The purpose of this amendment is to provide answers to questions posed by a potential offeror. The following information is provided:

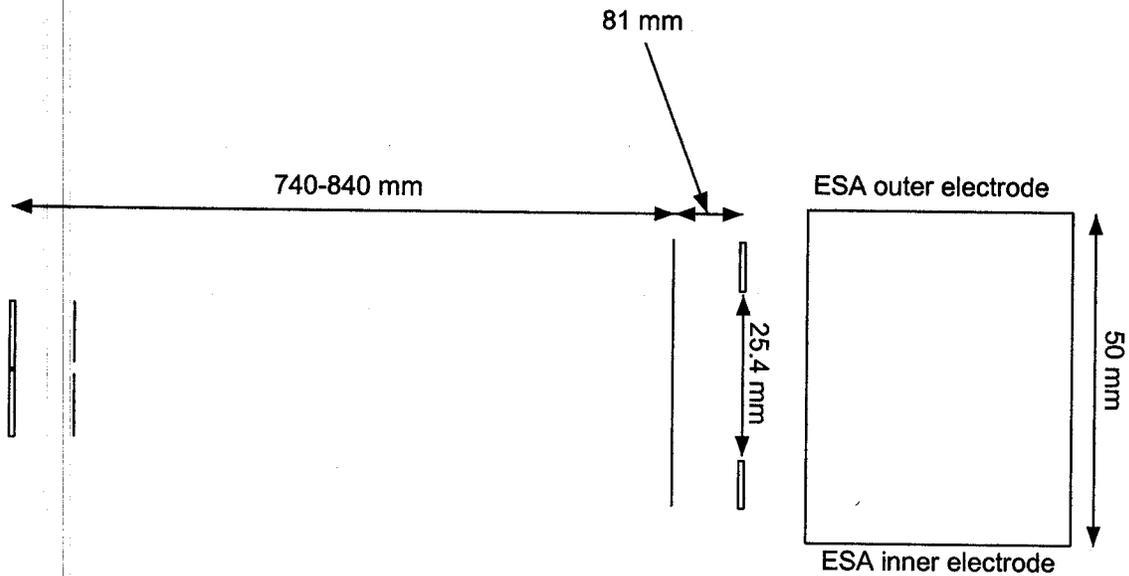
1. Regarding Detailed Specification paragraph e and the emittance angle, to respond, the beam angle half-aperture and diameter must be specified at given planes. NRL has not supplied this information.

2. Regarding Detailed Specification paragraph f, secondary beam transport, it is noted that beam emittance is determined by both the entrance slit and the opening aperture. The information concerning the opening aperture such as diameter and location has not been provided.

3. Regarding Detailed Specification paragraph g, ESA compatibility, is the NRL ESA located "74-84 cm **downstream** from the NRL ESA flange" ?

The sketch above is provided to help understand NRL's reply to the following questions. NRL considers the object position for the ESA to be located at the "SIMS entrance slit plane". The ESA opening aperture is a limiting factor for the acceptable beam angle. The secondary ion beam enters this drawing from the left, as indicated by the large arrow.

The beam angle at half aperture required can be determined from the "ESA opening aperture" (25.4 mm diameter) and distance between the "SIMS Entrance Slit Plane" and the "ESA opening aperture" (821-921 mm). Taken together, the beam angle at half aperture required is 15.1-17.2 mrad. For an example, for our lower acceptance of 1π mm mrad MeV^{1/2}, a beam angle of 15.1 mrad, and a beam energy of 10

keV, the beam size must be less than 2.1 mm at the "SIMS Entrance slit plane".

Diameter and location information have been provided in the answer to Question 1.

Per the opening remarks, the SIMS generated image at the "SIMS Entrance slit plane" is considered to be the object position for the ESA. Further, this location is to be 74-84 cm in front of the "NRL ESA entrance flange", or upstream of the "NRL ESA entrance flange", not downstream of it.
